Access Compliance Report

Public Rights-of-Way

(Curb Ramps)

Intersection ID: 29420	Main Street: BRADSTREET COMMONS_WY	Cross Street: SALINGER_WY	Location: N
ADA ID: 6F695BE8AFAA	Ramp Type: Perp	Initial Pass/Fail: Fail	Overall Compliance: No
Severity Score: 33.75			
Codes/Mitigation Info/Possible Solution		Field Measurements/Component Compliance

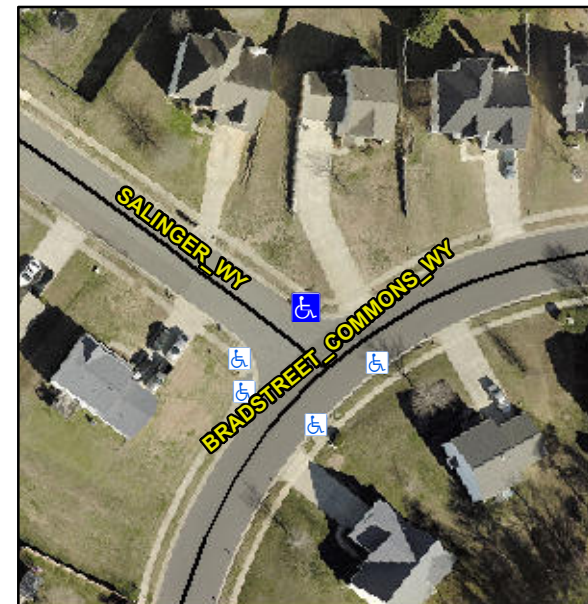
Not Found, R304.5.1, R304.5.3

Compliance	Description	Data	Compliance	Description	Data
N/A	Ramp Length (in)	48.0	Yes	Ramp Slope (%)	6.9
No	Ramp Width (in)	39.0	No	Ramp XSlope (%)	13.2
N/A	Flare Type LT	N/A	N/A	Flare Type RT	N/A
N/A	Flare Slope LT (%)	N/A	N/A	Flare Slope RT (%)	N/A
N/A	Flare Traversable LT?	N/A	N/A	Flare Traversable RT?	N/A
N/A	Landing Length (in)	N/A	N/A	DWS Provided?	N/A
N/A	Landing Width (in)	N/A	N/A	DWS Contrast?	N/A
N/A	Landing Slope (%)	N/A	N/A	DWS Length (in)	N/A
N/A	Landing X Slope (%)	N/A	N/A	DWS Full Width?	N/A
N/A	Landing Curb? (Y/N)	N/A	N/A	DWS Offset (in)	N/A
N/A	Shared Landing?	N/A			
N/A	Gutter Ponding?	N/A	N/A	Gutter Slope (%)	N/A
N/A	Gutter Lip Ht (in)	N/A	N/A	Gutter X Slope (%)	N/A
N/A	Painted X Walk1?	No	N/A	Painted X Walk2?	N/A
	X Walk 1 Direction	To SW		X Walk 2 Direction	N/A
N/A	X Walk 1 Width (in)	N/A	N/A	X Walk 2 Width (in)	N/A
	X Walk 1 Slope (%)	3.7		X Walk 2 Slope (%)	N/A
	X Walk 1 X Slope (%)	7.7		X Walk 2 X Slope (%)	N/A

Remove & Replace Entire Ramp.
